ADDENDUM 3

ADDENDUM DATE: November 19, 2024

PROJECT: Onslow County Senior Services Center Renovation
4024 Richlands Highway
Jacksonville, NC 28540

ARCHITECT: Smith Sinnett Architecture, P.A.
4600 Lake Boone Trail, Suite 205
Raleigh, North Carolina 27607

1 OVERALL SLAB AND FOUNDATION PLAN
S1-03 1/8" = 1'-0"

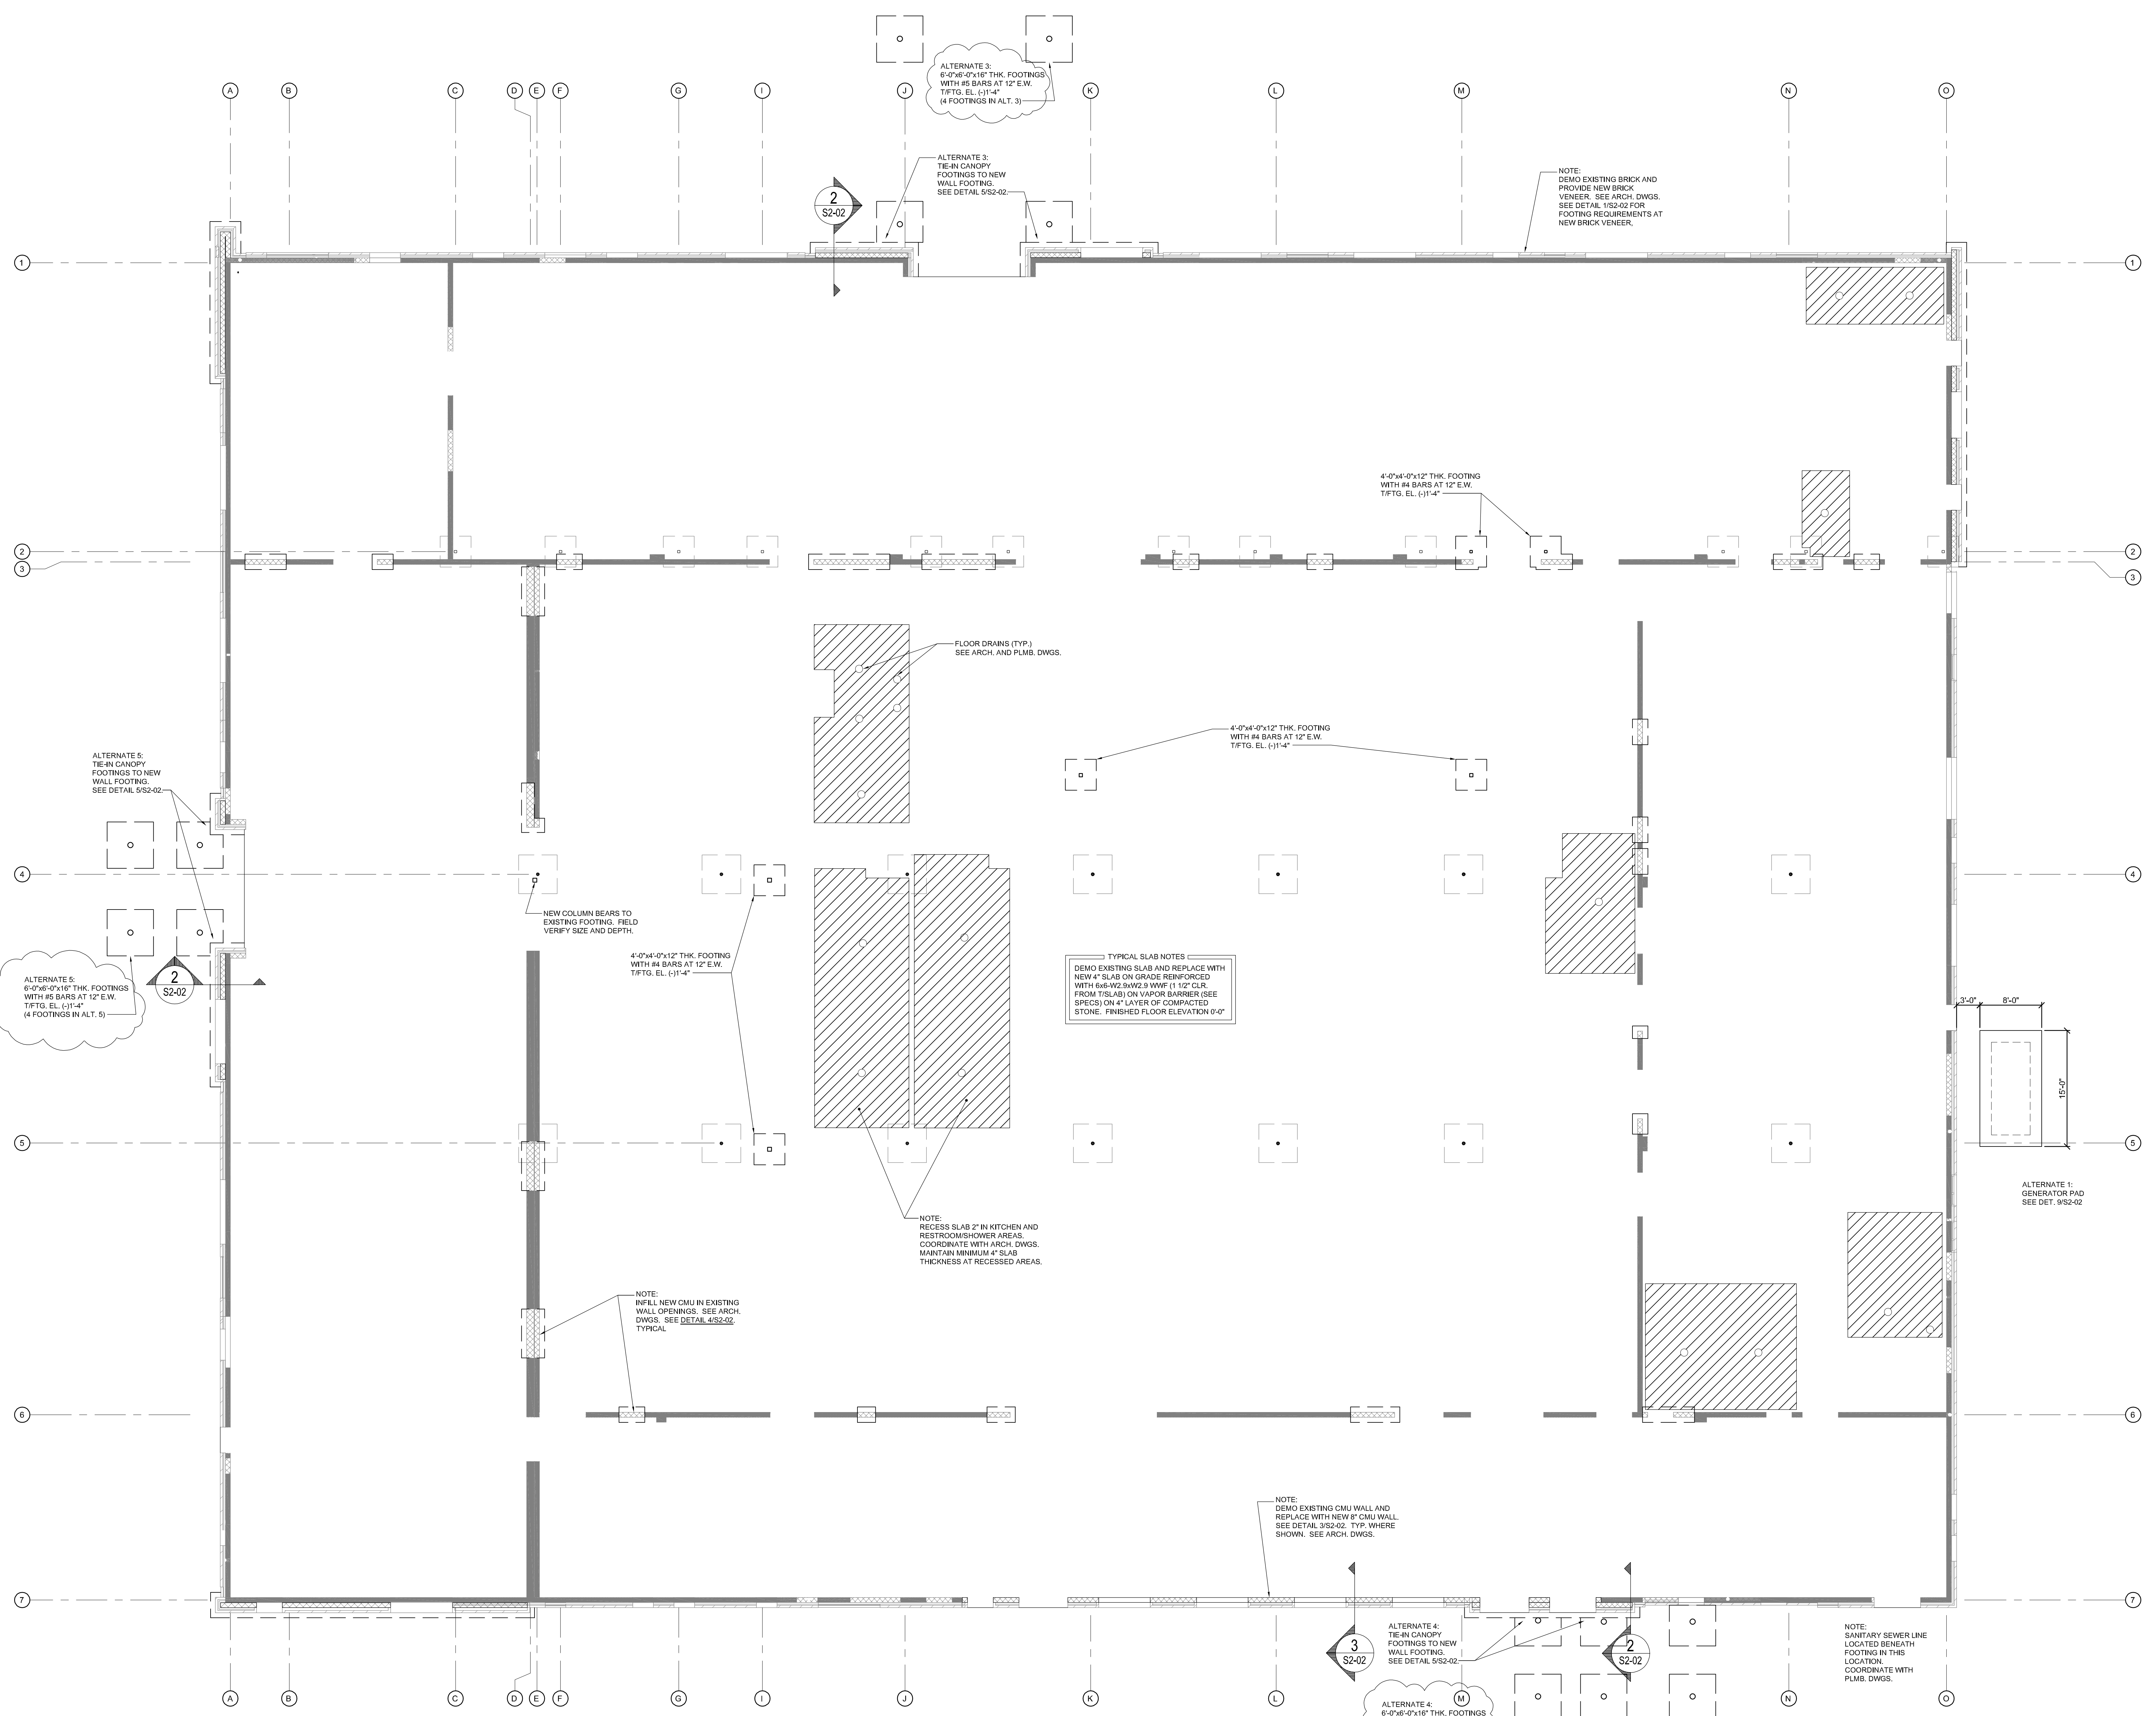
- Item 35 Contractor question: "On S1-03, Alternates 3, 4 and 5 refer to the column footings adjacent to the building. The exterior footings are not tagged as part of the respective alternates, can you please confirm whether these columns are to be included in the base bid or alternate?"

Response: Column footings supporting roof framing associated with canopies per Alternate 3, 4 and 5 respectively shall be included with said Alternate. Refer to S1-03 attached to this addendum.

1
A0-04 DEMOLITION REFLECTED CEILING PLAN - AREA A
1/8" = 1'-0"

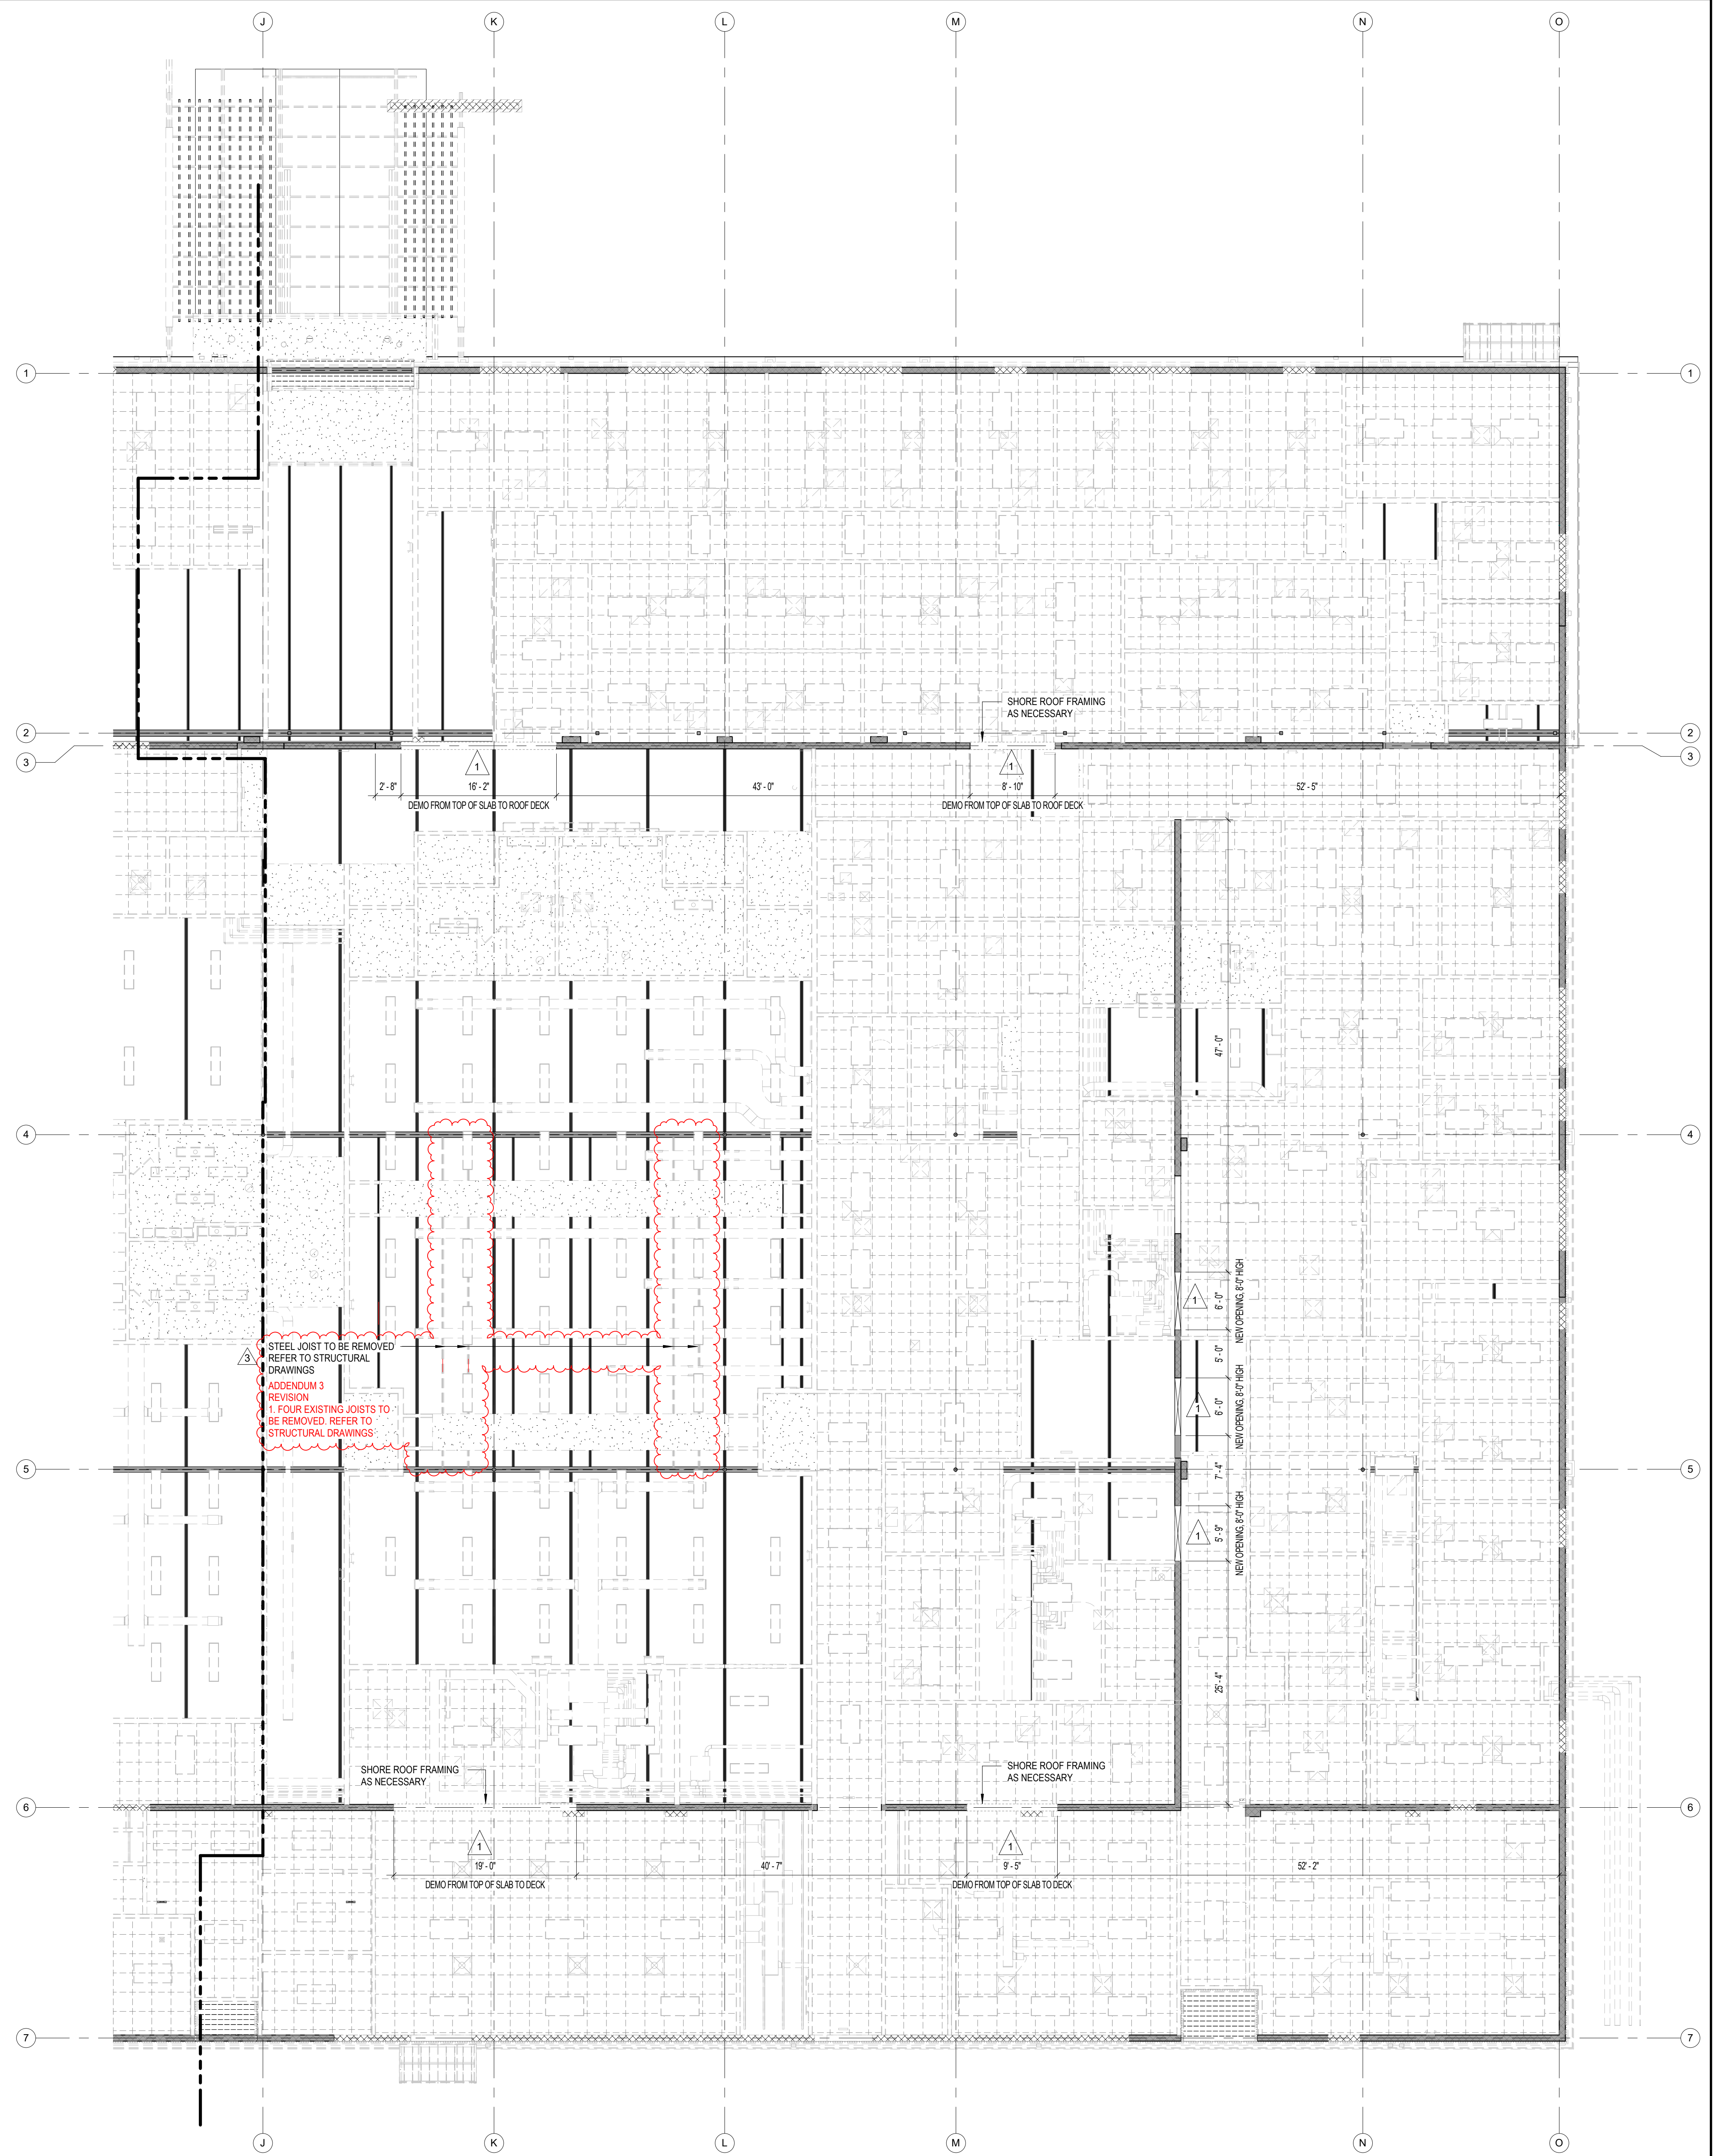
- Item 52 Sheet A0-04: REPLACE the sheet in its entirety with the attached sheet A0-04.
Note the following revisions:
- Four existing joists to be removed. Refer to S1-01 attached to this addendum.
- Item 53 Sheet A0-06: REPLACE the sheet in its entirety with the attached sheet A0-06.
Note the following revisions:
- The extents of existing skylight demolition have been revised as indicated on demo roof plan.
- Item 54 Sheet A1-02: REPLACE the sheet in its entirety with the attached sheet A1-02.
Note the following revisions:
- The aluminum window between Lobby 101 and Reception 102 changed to AL9.
